MUNICIPALITY OF ANCHORAGE

From: Daniel King
Engineering Services Manager
MOA Development Services Department

Re: Proposed Amendment to ASME A17.1-2019 Section 2.7.6.2

Figure Q-2

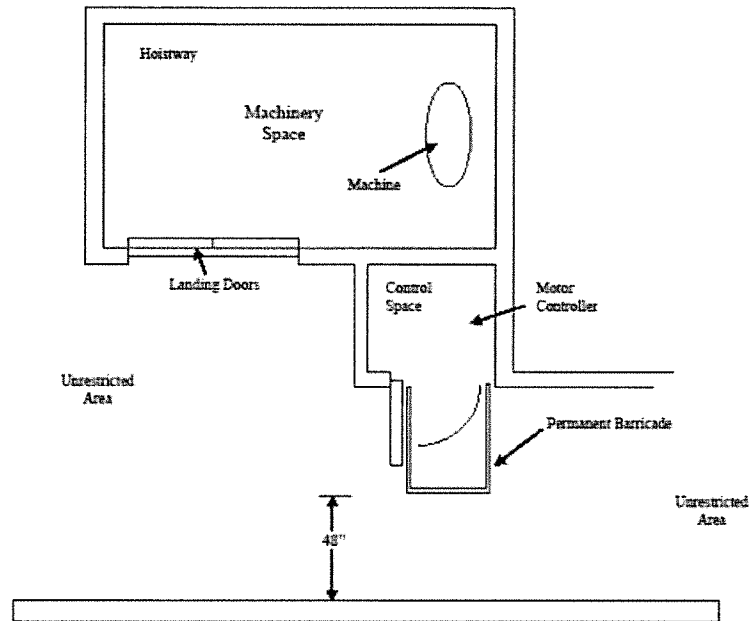
(d) A control space and machinery space for elevators must only be located where working clearances required for the control space will not impede upon the path of travel in unrestricted areas. Where the elevator control space is located in a path of travel in an unrestricted area, a clear path of travel parallel to the control space must not be less than the required working clearance plus 1219 mm (48 in.) perpendicular to the control space. A permanent barricade needed to establish the working clearances for the control space must be accessible to elevator personnel from the control space. The barricade must be deployed whenever the doors to the control space are in the open position. See Figure Q-2.

FINAL LAYOUT

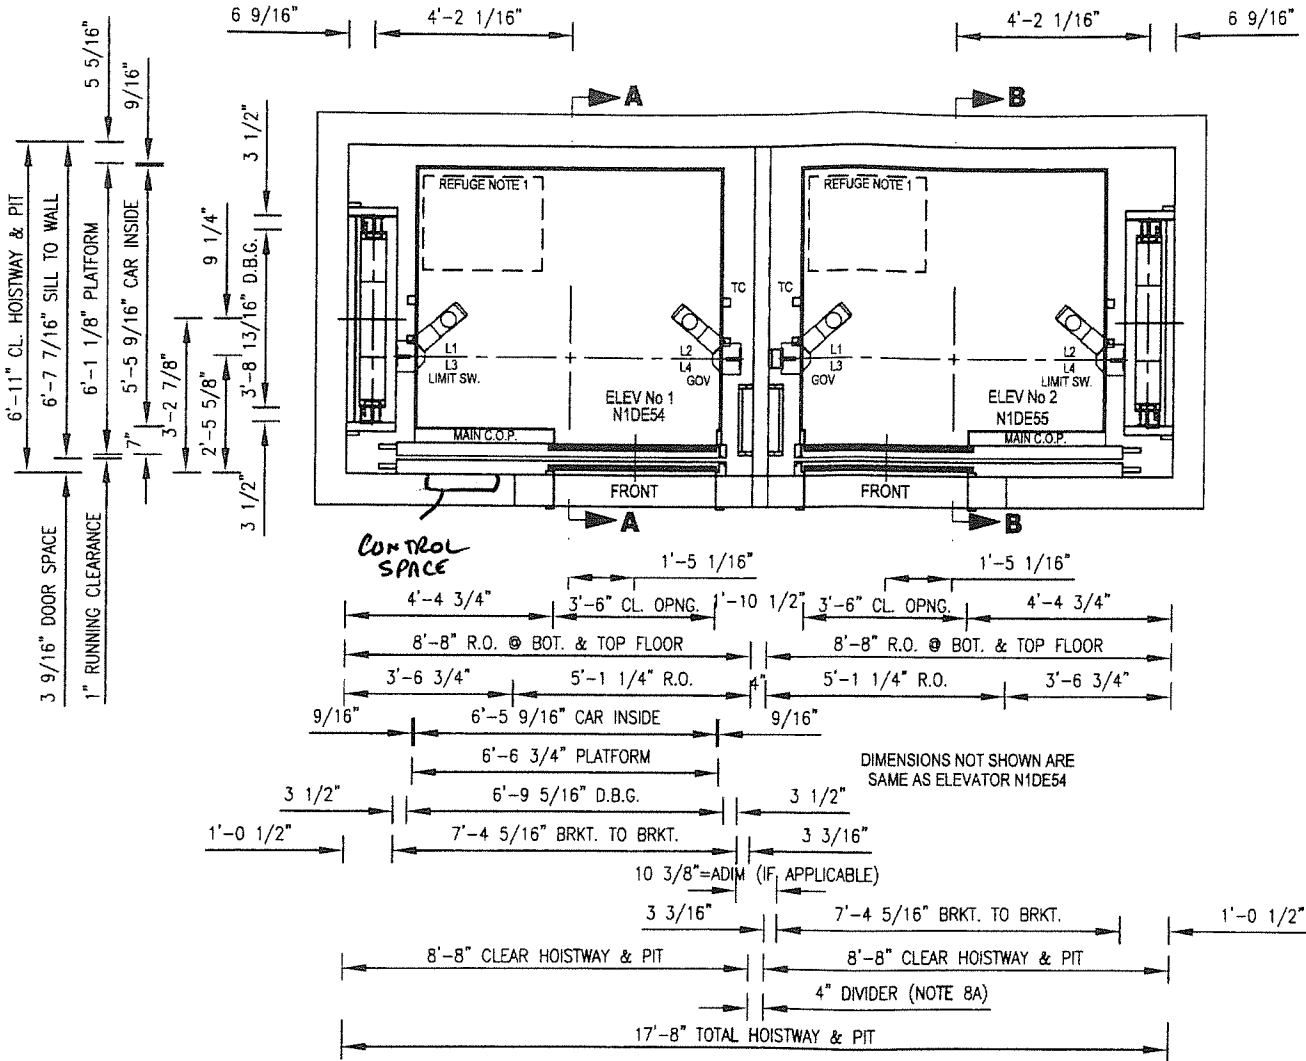
Reason 4 recognizes that NFPA 70 Article 110.26 requires open and clear access to electrical panels and equipment, where the control space in the hoistway is often impeded by the elevator doors. NEII asserts that this is not an argument used in other jurisdictions.

MOA Response: The elevator doors will often impede access to the control space when the door is in the open position. This requires that the doors be closed to access the panel. When NEII says this is not an argument in other jurisdictions, they ignore that the amendment to disallow a control space within the elevator hoistway has been adopted by New York City, Seattle, and California State. The language utilized by the MOA to propose this change is taken directly from the New York City local amendment. This has been determined by large jurisdictions throughout the United States as a dangerous condition. See attached amendment from New York City building code.
